INDIANA DEPARTMENT OF TRANSPORTATION

February 19, 2015 Standards Committee Meeting

RE: Agenda for the February 19, 2015 Standards Committee Meeting

808-MKPM-03 TRANSVERSE MARKINGS (WITH MARKUPS)

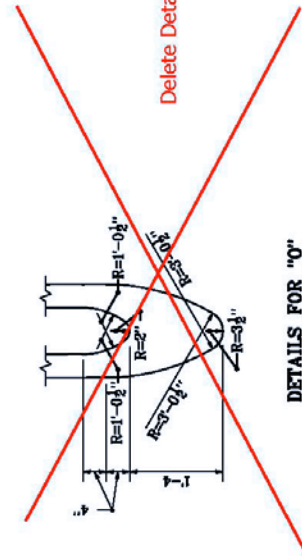
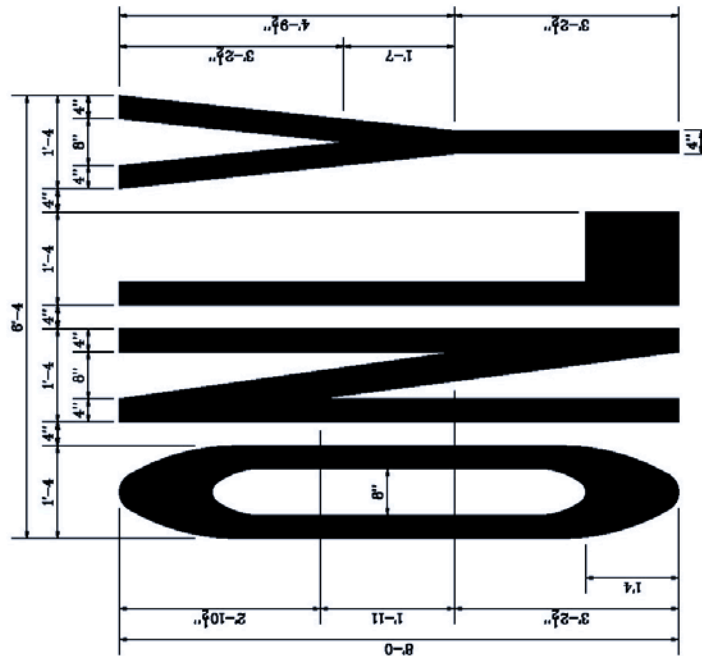
Also show "X-ING" layout on this drawing

Delete Detail (Replace by showing grid lines)

808-MKPM-03 TRANSVERSE MARKINGS WORD MESSAGES (PROPOSED DRAFT)

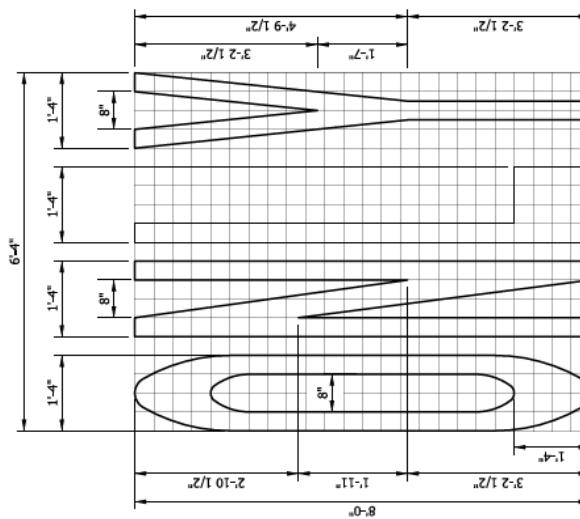
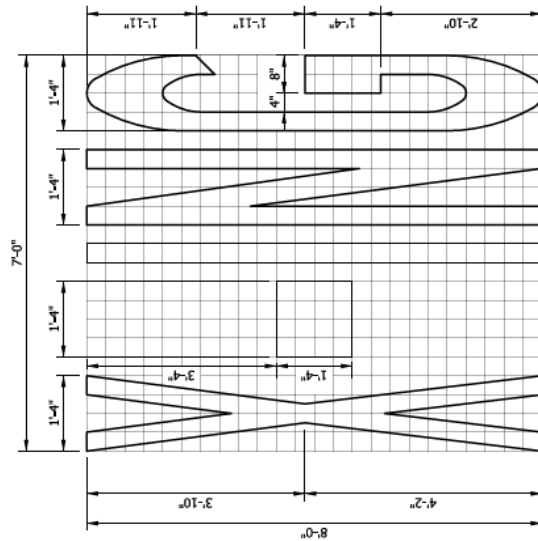
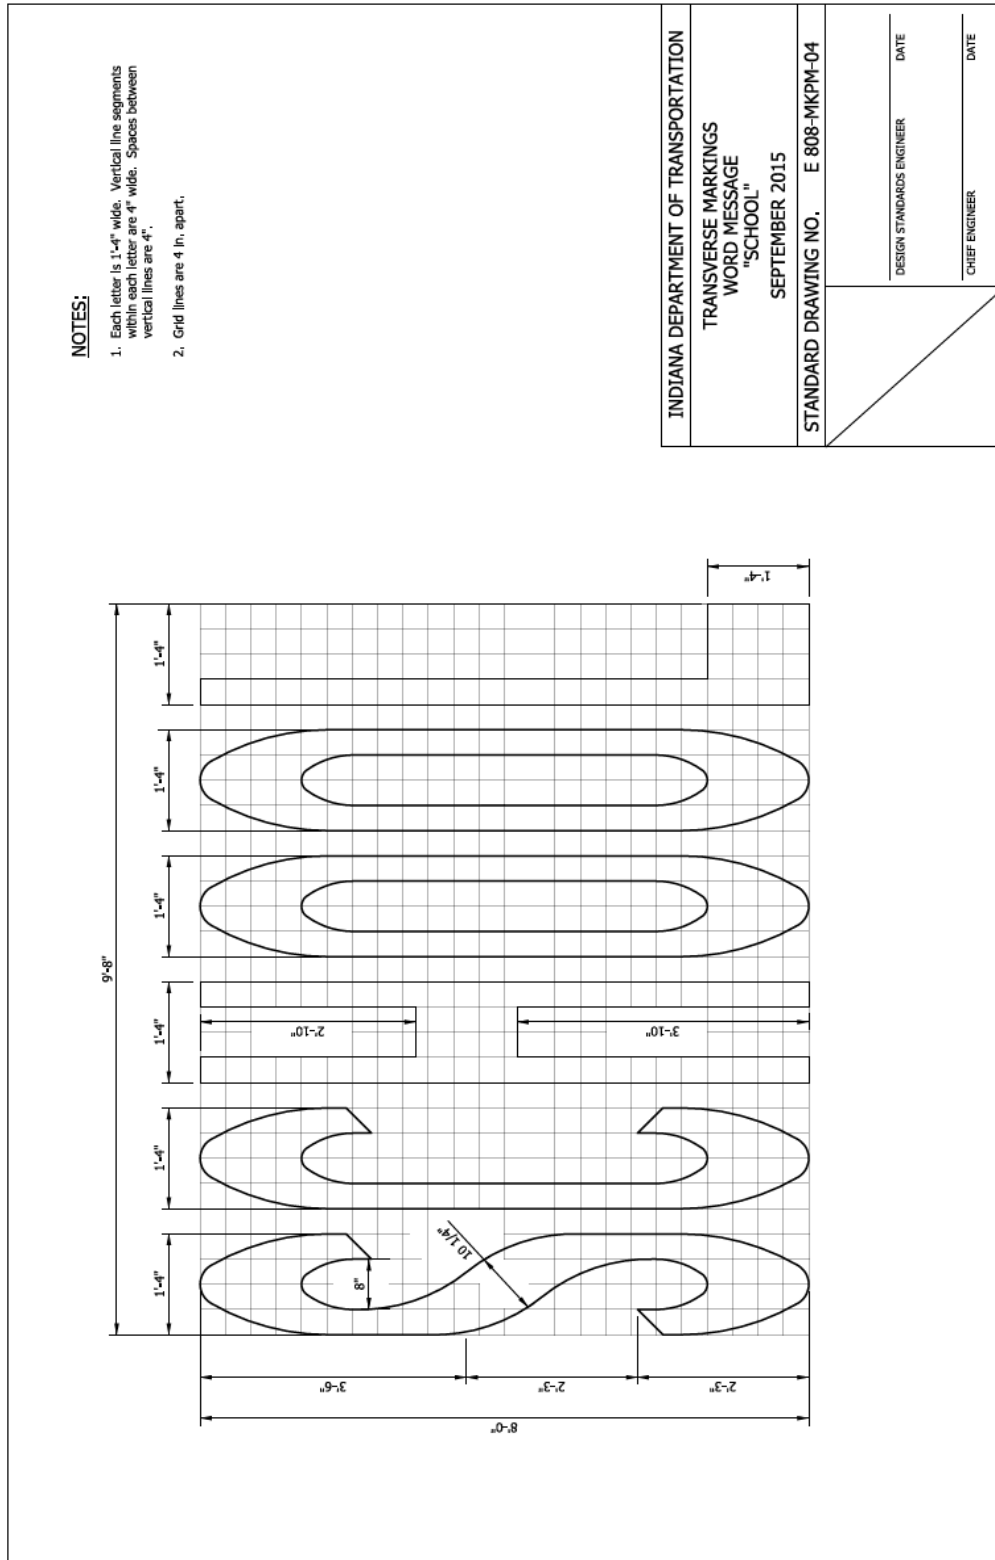
1. The top part of the word **ONLY** shall be placed prior to the lane indication arrow, 32 ft for posted speeds ≤ 45 mph but not more than 80 ft for posted speeds > 45 mph.
2. Each letter is 1'-4" wide. Vertical line segments within each letter are 4" wide. Spaces between vertical line segments are 4".
3. The grid lines are 4 in. apart.
